Memorandum

Reference 925-3272/M2

Safkeg LS 3979A- Mesh Sensitivity Analyses

Figure 1: Finite element mesh

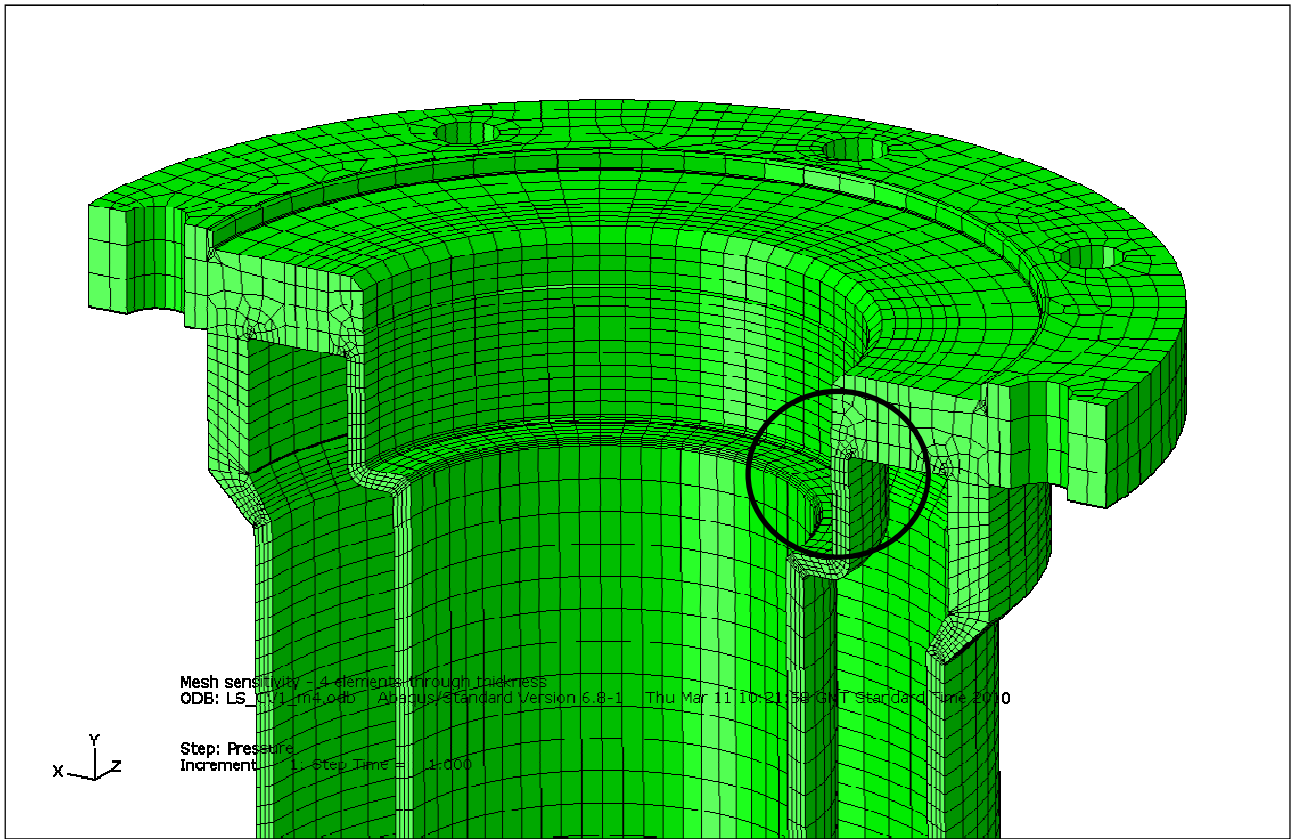
The region circled in Figure 1, at the join between the body and the top flange, was the part of the model where the mesh was refined. The number of elements through the thickness of the body was increased from 4, as used in the original study, to 6, 8, 10, 12, 14 and 16. In all cases, the number of elements along the length of this section was adjusted so that the aspect ratio of the elements (length of one side of an element to the other side of the element) was maintained. All of these cases used first-order elements, as used in the original study. Two additional cases used second-order elements. Both of these cases used 16 elements through the wall thickness, but one used 4 elements around the fillet radius, as used in all the other cases, and one used 8 elements around the radius. The results using second order elements are considered to be closest to the actual stresses, however for reasons of computation power and model size, it is not always possible to use these elements because the contact algorithms, which were required in the main study, are not efficient with second order elements, hence the need, as in this case, for the use of fewer, single-order elements.

Figure 2: Stress profile through wall

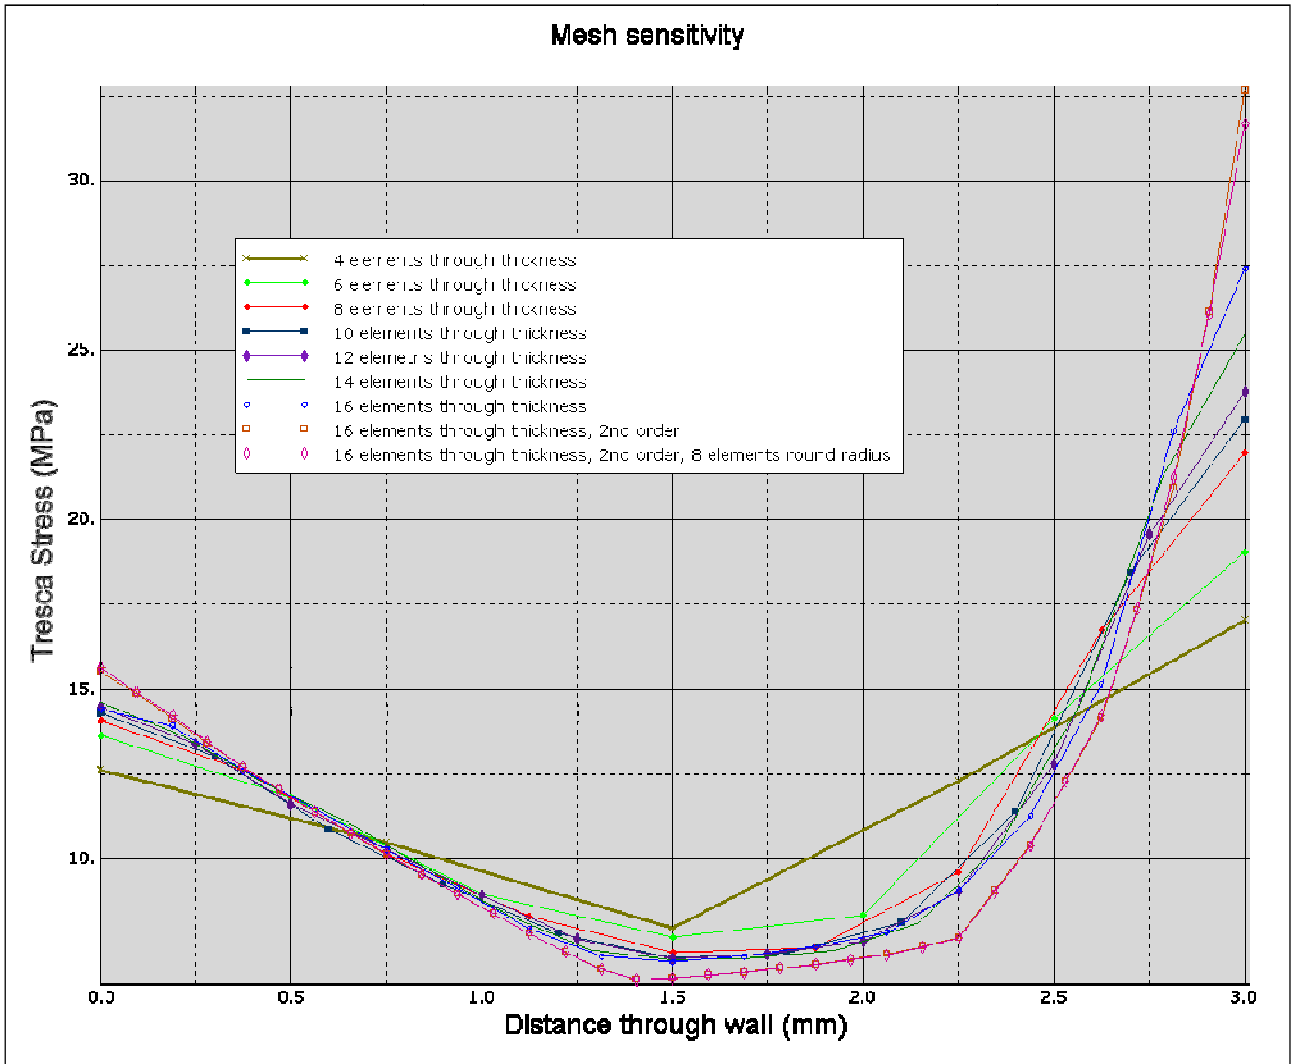
Figure 2 shows the stress profile, from the inside to the outside, at the junction between the body and top flange for all the cases. The stress shown is Tresca, which is the same as the stress intensity as required by NRC Regulatory Guide 7.6. The model with 4 elements through the thickness produces a profile which, whilst a fair representation of the actual stress profile, does under predict the peak stresses; however, the results are sufficient to give a good approximation to the deformations of the container, as described below, and hence their use for most flask impact analyses. The accuracy of prediction of the peak stresses improves the greater the number of elements through the thickness, as might be expected. As stated above, the results using second order elements should give an accurate profile. The case with 8 elements around the radius had a slightly smaller peak stress and the case with 4 elements around the radius.

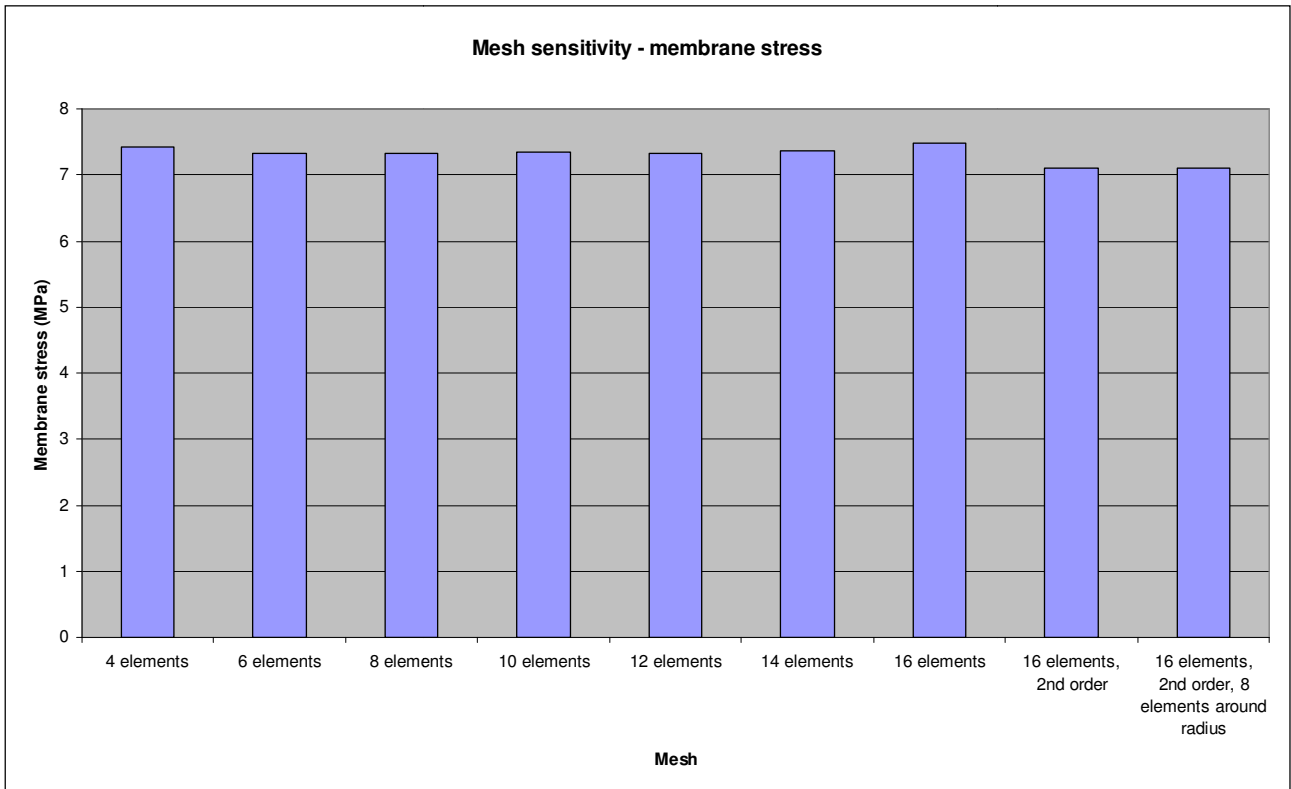
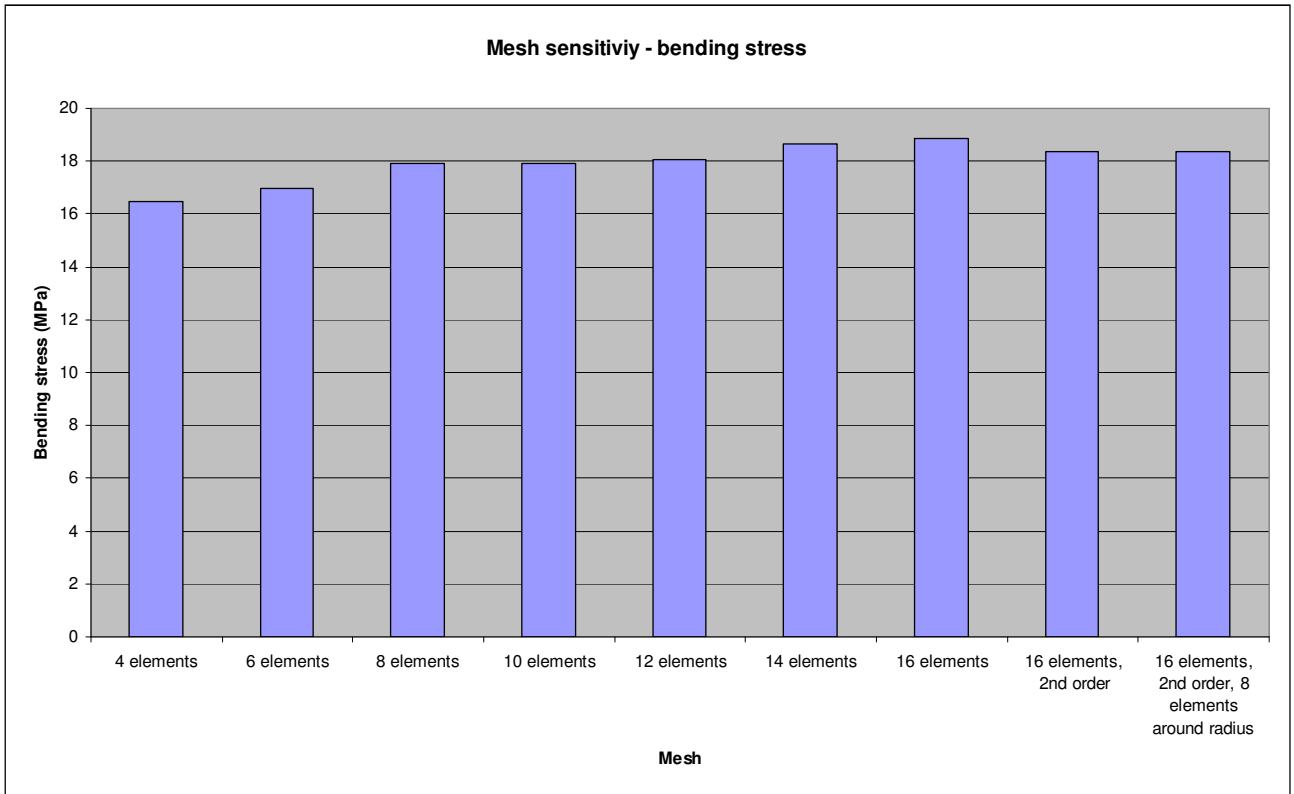
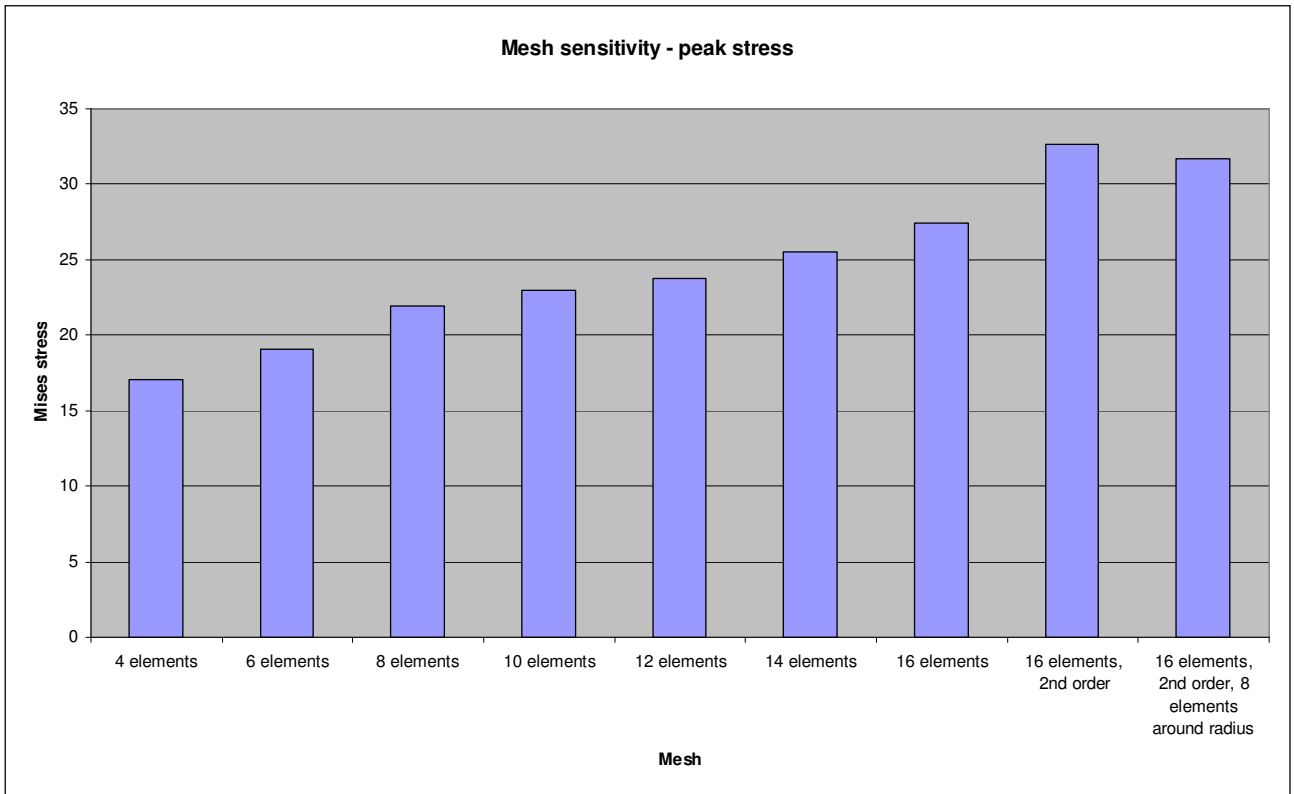
For the assessment of the containment vessel, membrane, bending and peak stresses were calculated and compared with allowable values. The membrane, bending and peak stresses for this study are given in Table 1 and figures 3-5. The variation in membrane stress was only 6%, the variation in bending stress was 14% and the variation in peak stress was 92%. If we take the final case, second order elements and mesh refinement around the radius, as being closest to the correct answer, the difference between this and the first case with 4 elements was -4%, 11% and 86% for the membrane, bending and peak stress respectively. For the HAC cases, the peak stress is not assessed as it does not affect the predicted deformations of the container during impact.

For the NCT cases, the peak stress result is more important as it affects the fatigue life. The influence of peak stress vs profile is not straightforward, due to the restraining influence of the lower stressed material within the bulk of the section, however as a conservative approach Vectra has reviewed all the stresses results from the original study and has applied an 86% increase to all of the peak stresses. The design margins were still above zero in every case.

1. The mesh used in the original study was adequate for the HAC cases as it produced reasonable estimates of the membrane and bending stresses.
2. The mesh used in the original study was less able to accurately capture peak stresses. A very refined mesh, using second-order elements is required to accurately capture the peak stresses at some locations. However, for reasons of model size and computational capacity, it is not generally practical to use this level of refinement in the main study.
3. All the stresses from the original study have been reviewed and peak stresses have been scaled by a factor of 1.86 based on the results of this sensitivity study. All of the design margins were still above zero, thus confirming that, even with a very conservative assessment, the design is still acceptable.
